PROPOSED GROUND FLOOR PLAN
 (As Proposed By Architect-Over marked with Structural Recommendations)
 (Scale 1:100)

PRELIMINARY ISSUE FOR PLANNING & CONSERVATION
 DISCUSSION NOT FOR BUILDING CONTROL OR CONSTRUCTION

EDGE DESIGN CONSULTANCY STRUCTURAL ENGINEERING e-mail: edgcd@hotmail.co.uk	NEW BRAKES FARM, SWINE FLEET, DN14 8DZ CLIENT: Mr D Rimmington Architectural plans, over marked to show structural member sizes.
	Date 10/2022	Sheet size: A3

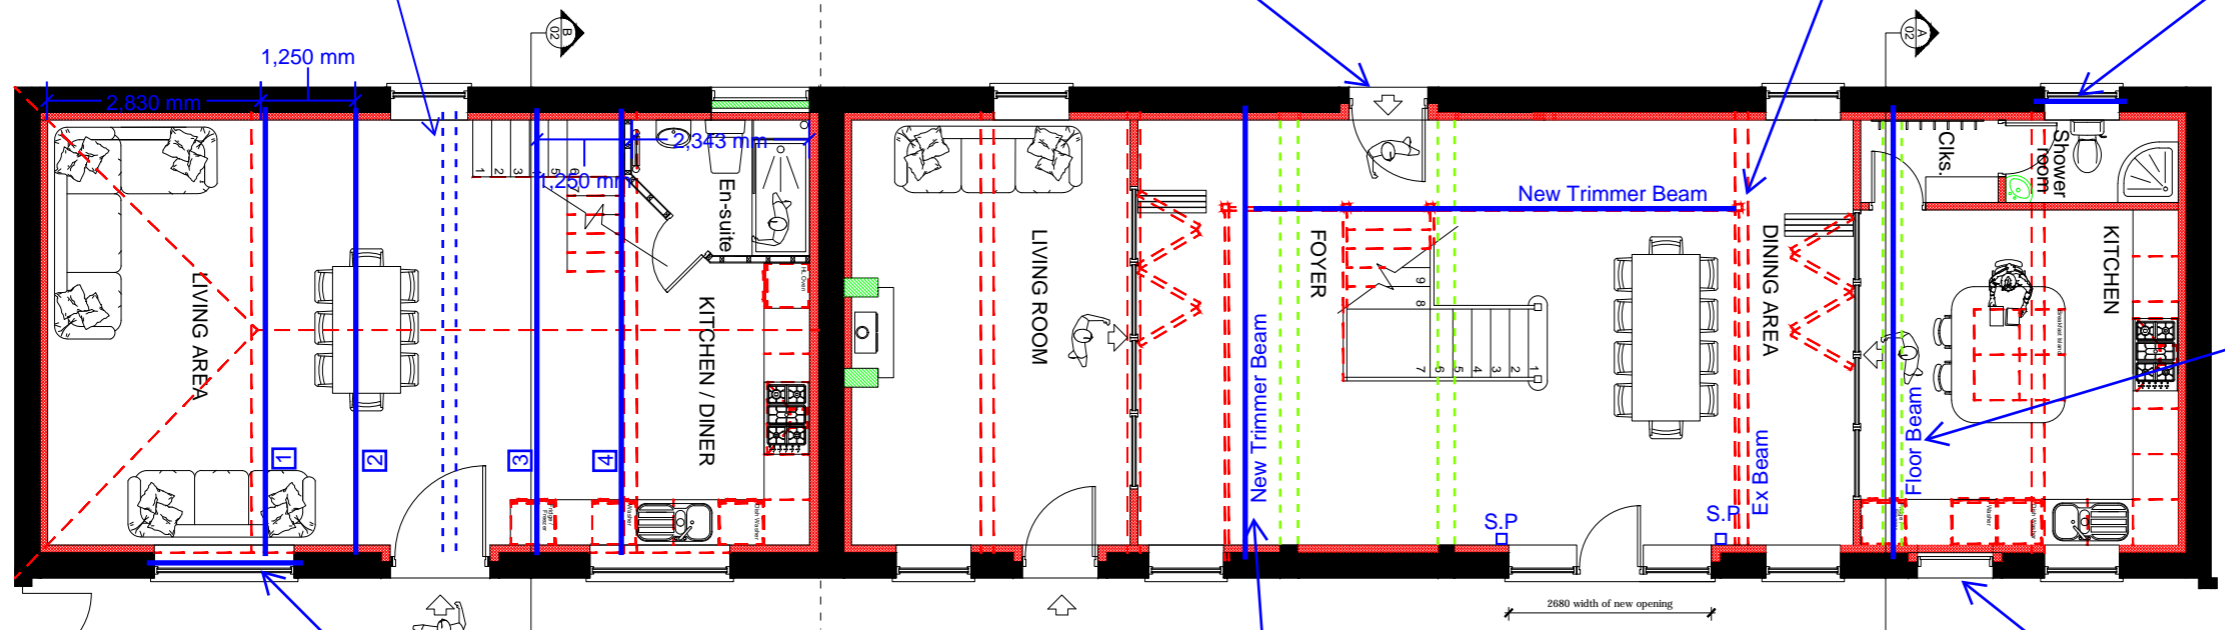
OPTION 1 (AS PROPOSED)
 1 = New floor beam
 2 = New room in roof truss
 3 = New room in roof truss
 4 = New floor beam
 NOTE: New trusses to be max 1.25m away from king post trusses.

Existing suspect scissor truss to be replaced with 2 number new "room in the roof" to reduce the loads on the existing kingpost trussed, so that they can be retained without the need to strengthen, and to allow new first floor habitable floor space.

Existing masonry arch head damaged to be rebuilt.

Existing timber floor beam to be checked for new point load from trimmer.

New window opening to be formed will require lintel beam.

King post truss currently bears onto window lintel. Steel lintel beam to be installed for adequate support.

Trimmer beam for edge of landing will need to be offset roughly 300-400mm from the window opening, making the landing wider, to prevent a bearing clash with the window lintel.

Existing masonry arch head failing with step cracking. EDC recommends masonry arch rebuilt and strengthened using helical bars.

Floor beam required to support existing floor joists due to proposed demolished solid wall.

PROPOSED GROUND FLOOR PLAN
(Over marked with Alternative Layout's Structural Recommendations)
(Scale 1:100)

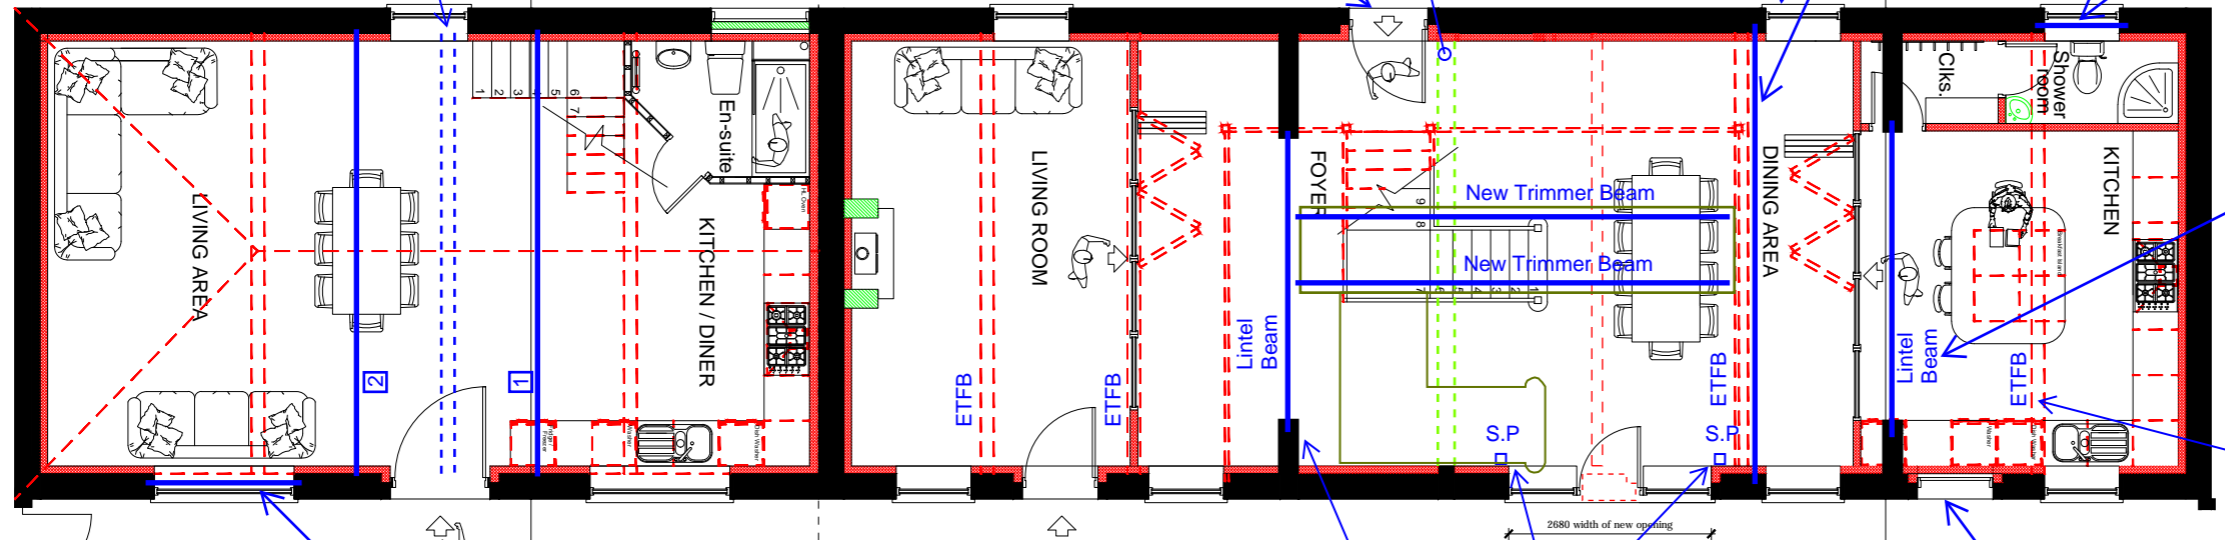
OPTION 2 (ALTERNATIVE - REMOVE MEZZANINE)

1 = New scissor truss
2 = New scissor truss
NOTE: New trusses to be max 1.25m away from king post trusses.

Existing suspect scissor truss to be replaced with 2 number new scissor roof trusses to reduce the loads on the existing kingpost trussed, so that they can be retained without the need to strengthen.

Existing masonry arch head damaged to be partial rebuilt / reposition 3No. bricks.

Existing internal brick wall, shown removed, but could new layout keep the same amount of wall as for opening into kitchen and living at the rear wall and one brick at the front?

New window opening to be formed will require lintel beam.

Existing timber floor beam to be strengthened for new partition wall above and fly gallery.

OPTION 2 (ALTERNATIVE)
Retain parts of the existing internal walls to minimize intervention.

New window opening to be formed will require lintel beam.

Client can choose to keep solid wall and create wider opening with min 600mm return on both sides, thus not requiring floor beam. This would slightly reduce floor space in kitchen as the proposed stud wall would be replaced by the existing solid wall. A beam will be required to support the masonry above the opening as shown.

ETFB = Existing timber floor beam at 1st floor level

King post truss currently bears onto window lintel. Steel lintel beam to be installed for adequate support.

Existing solid wall to be kept to reduce the number of new beams required. Edge of landing to be supported by solid wall at ground floor level. This will also allow a larger living room space but reduce the open foyer area. Opening in solid wall to be mirrored with solid wall opening into kitchen with a lintel beam.

S.P. = Steel post / columns to be face fixed to inside face of masonry walls to restrain the existing masonry walls either side of new wider, two storey high opening.

Existing masonry arch head failing with step cracking. EDC recommends masonry arch rebuilt and strengthened using helical bars above the arch.

PROPOSED FIRST FLOOR PLAN
(Scale 1:100)

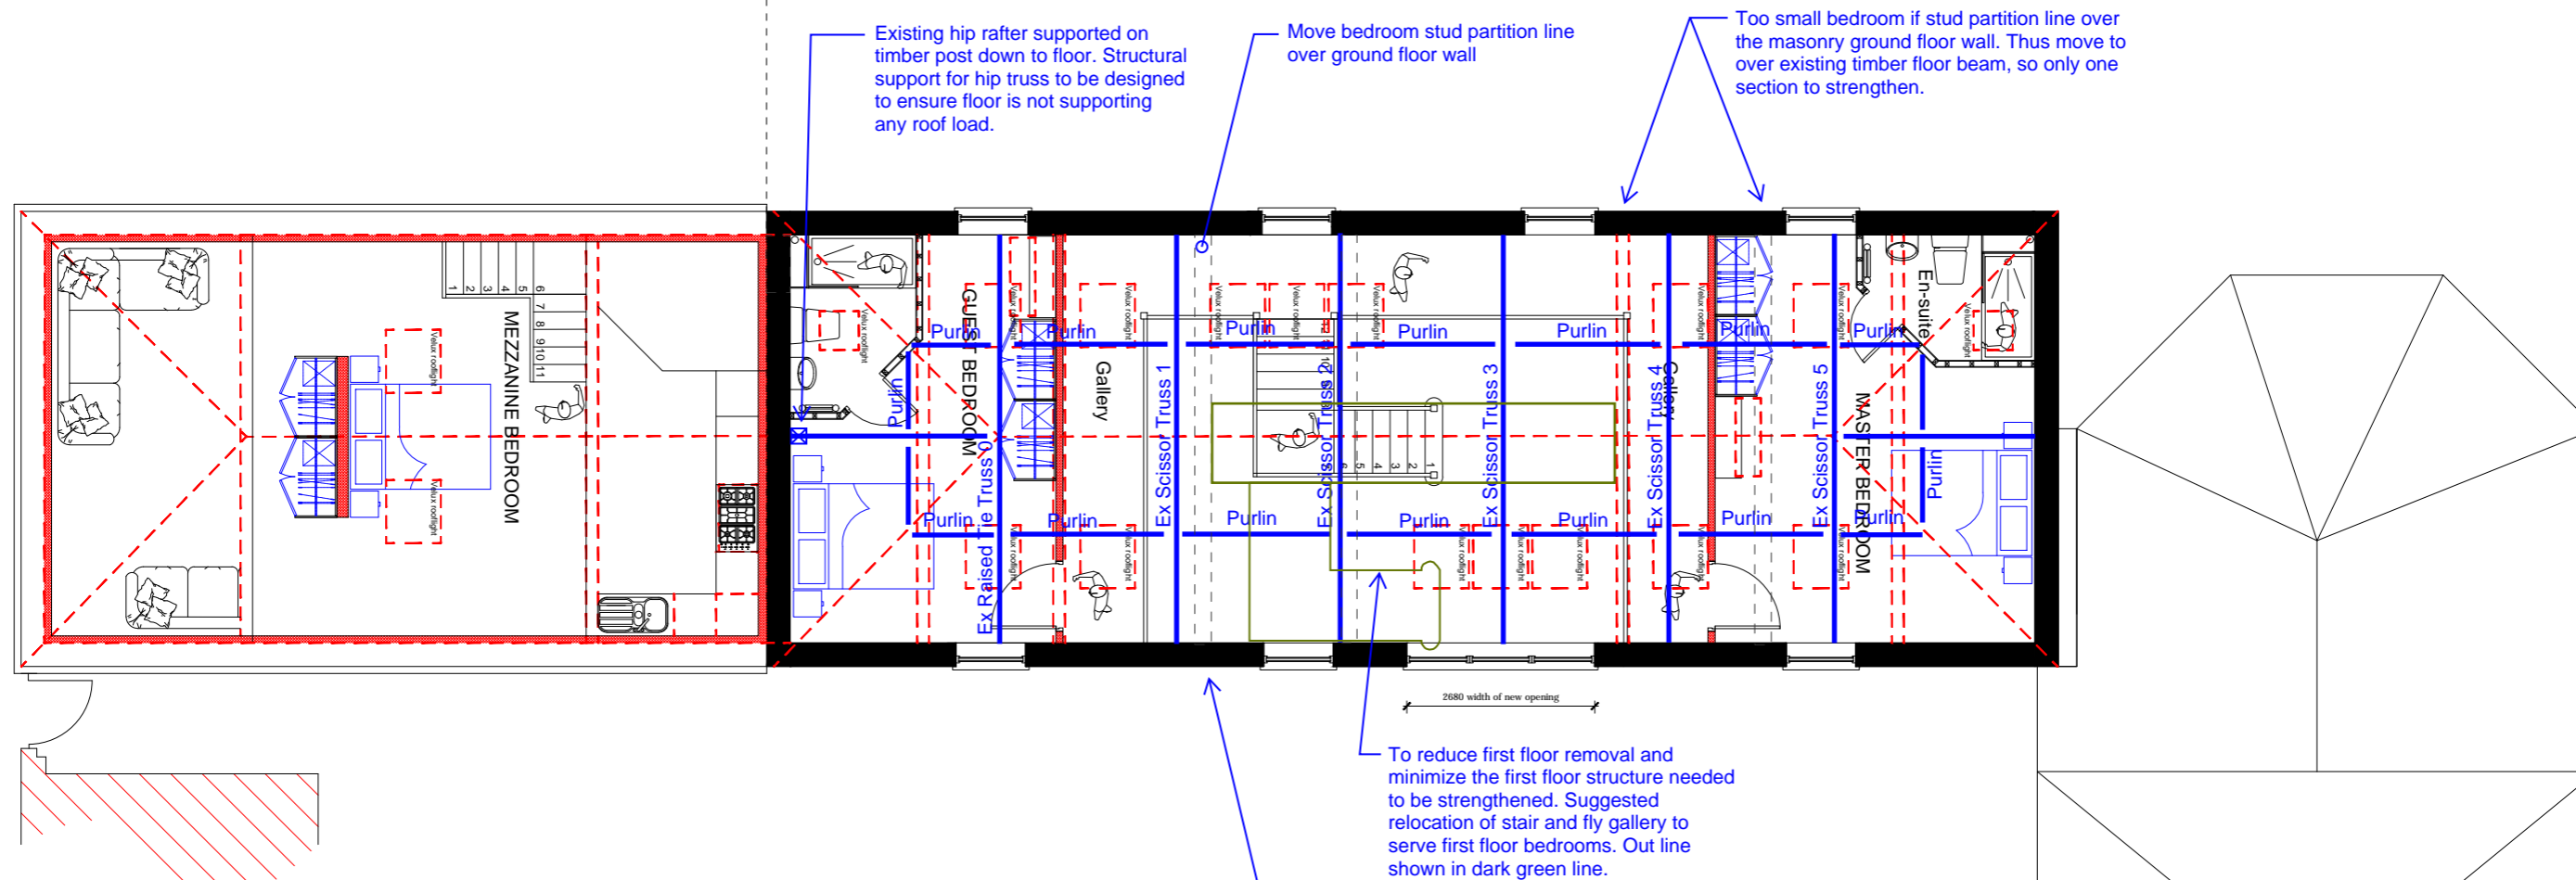
First floor section front wall to be rebuilt to correct substantial lean. Rebuilt wall width to match existing masonry width at ground floor level (360mm). At first floor level to rebuild with reclaimed brick an inner leaf would seem dishonest to the original build, but leaving would be unsafe in the long term. Recommend honest with repair by adding block leaf to inner and lime plaster over to hide new concrete block used to strengthen the existing external brick leaf. Ensure scaffolding erected before any structural works takes place including removal of roof for health and safety purposes. Existing wall width though only to be circa 110mm wide.
